Studebaker

SERVICE BULLETIN

NO. 254

1951

ORIGINAL TYPENEW TYPE

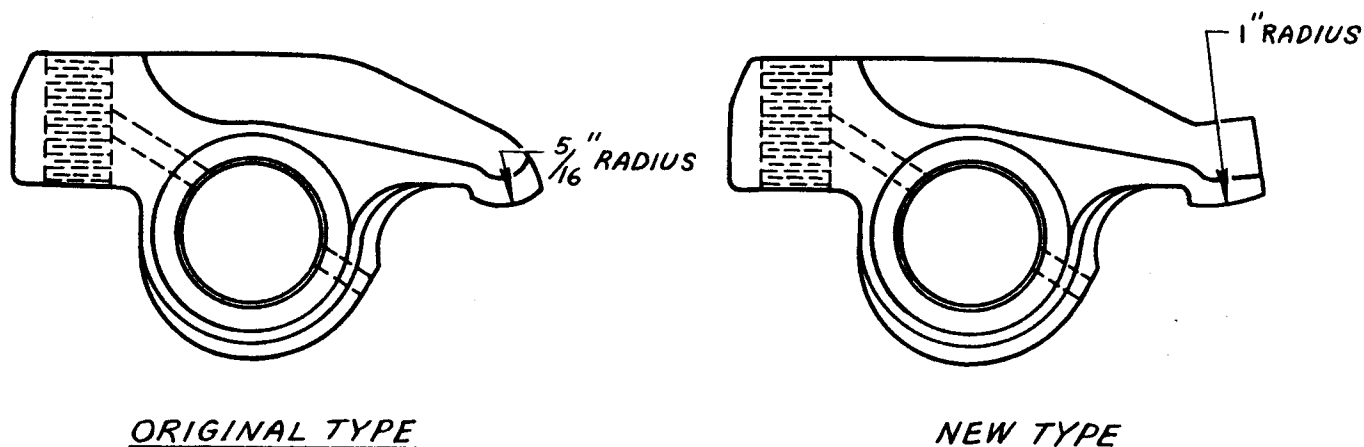
Effective with Engine No. V-37230 (VC-808 in Canada), the radius on the valve contact point of the rocker arm was increased from $5/16$ " to 1". This results in a much greater bearing area and reduces the possibility of excessive wear at the end of the valve stem. The new rocker arm, Part No. 529432, will be available through your parts depot. See accompanying drawing showing both original and new type rocker arm.

Refacing Valve Stem Ends

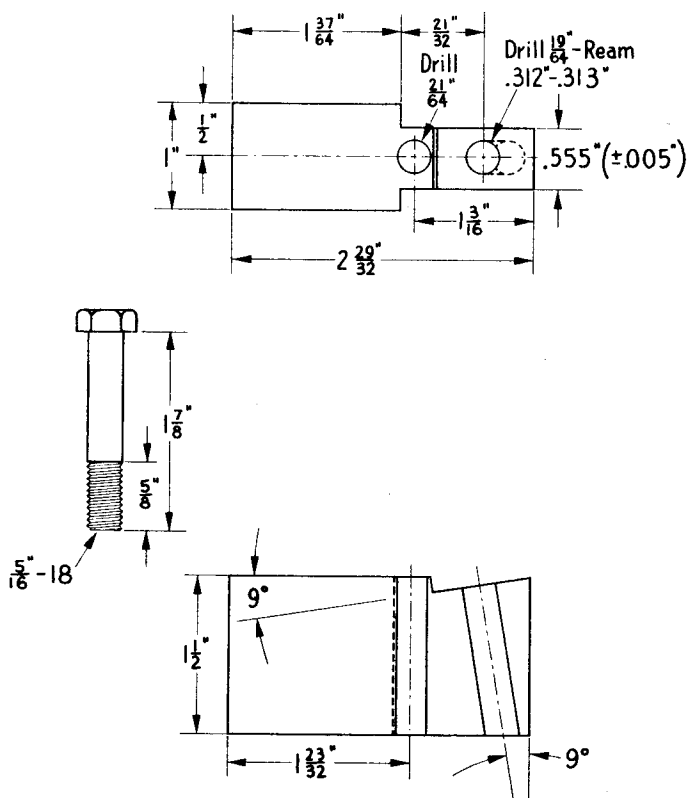
Badly worn valve stem ends should be refaced, using your valve seat grinder, a $2-1/4$ " stone, and the fixture described and illustrated below. Before having the fixture made, be sure you can obtain the $2-1/4$ " stone and that it can be used with your valve seating equipment

The fixture is made from $1-1/2 \times 1 \times 2-29/32$ " cold drawn steel. It can be made locally in any good machine shop in about two hours. Dimensions, drilling, and reaming are given in

The base of the fixture is designed so that it can be wedged between any pair of valve springs. The wedging action serves to push the springs apart, exerting pressure against the seats and seat retainers and thus forcing the valve stems tightly against the valve stem guides. When using the fixture, be sure this wedging action is effective; otherwise the refacing stone may chatter and a poor refacing job result.

The fixture should be firmly secured to the

cylinder head with the special screw shown in the drawing. Contact surfaces of the fixture, cylinder head, and valve springs should be clean and free of dirt. Valve spring dampers can be rotated if required so as not to interfere with the operation of the fixture and refacer.

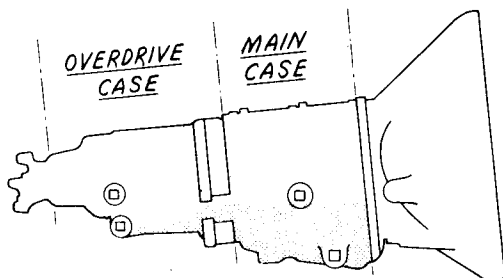
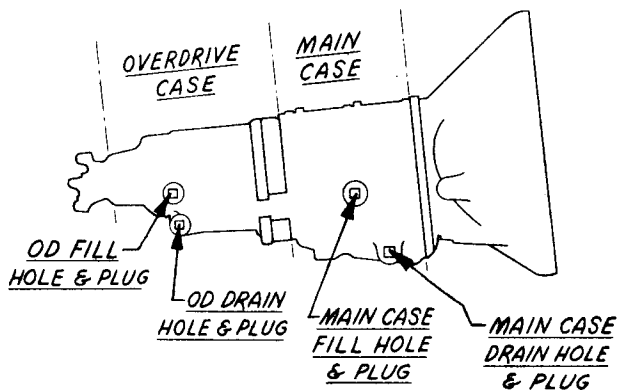
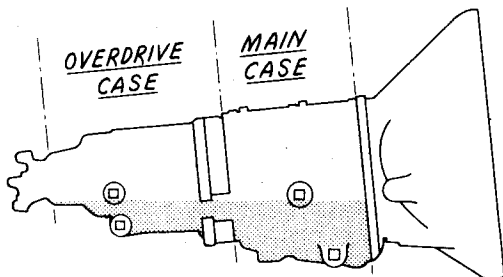
Since the service man is in reality filling two cases through one hole, it is important that he allow ample time for the lubricant to flow from the main case to the overdrive housing. The accompanying drawing illustrates how too rapid filling can result in low lubricant level which in turn may result in damage to the transmission.

TOO RAPID FILLING DOES NOT ALLOW ENOUGH TIME FOR LUBRICANT TO REACH PROPER LEVEL IN OD CASE WHEN MAIN CASE APPEARS TO BE FULL.

SLOW FILLING THROUGH MAIN CASE ALLOWS LUBRICANT TO REACH CORRECT LEVEL IN BOTH CASES.

In order to determine when the overdrive case is filled to the proper level, lubricant should be flowed slowly into the main case fill hole. When the lubricant has reached the level of the overdrive case fill hole, this plug should immediately be installed. Then continue to add lubricant to the main case until the bottom of the main case fill hole is reached, at which time both cases will be filled to proper level and the main case fill hole plug should be installed.

OIL LEVEL GAGES FOR VARIOUS MODEL OIL PANS - M AND 2R SERIES

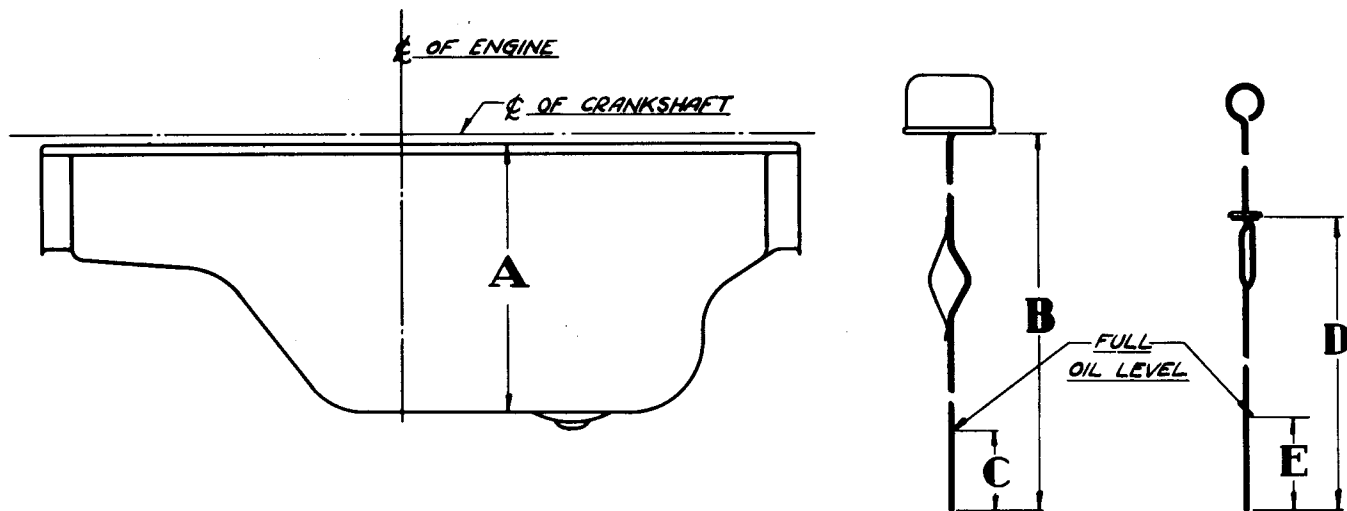
The above drawing, table, and footnote cancel and supersede similar information pertaining to the oil level gages and oil pans of various M Series and 2R Series trucks given in Service Bulletin No. 236, page 6.

From time to time, as truck models change, dimensions of the engine oil pan and also of the oil level gage are changed. This makes it possible in service replacement of the pan or the gage to have the wrong gage for the pan on the truck. As a result, inaccurate oil level readings may be taken.

The accompanying illustration and chart show how measurements of the gage and pan indicate whether the correct gage is being used. Likewise, the chart should be consulted whenever

* NOTE:- WHEN "A" DIMENSION MEASURES 6⁷/₈ THE OIL LEVEL GAUGE USED MUST BE DETERMINED BY THE CYLINDER BLOCK NUMBER WHICH IS CAST ON THE LEFT SIDE OF THE ENGINE ABOVE THE GAUGE HOLE. FOR CYLINDER BLOCK *199193 USE GAUGE *520225.-FOR CYLINDER BLOCK *523140 USE GAUGE *523184.
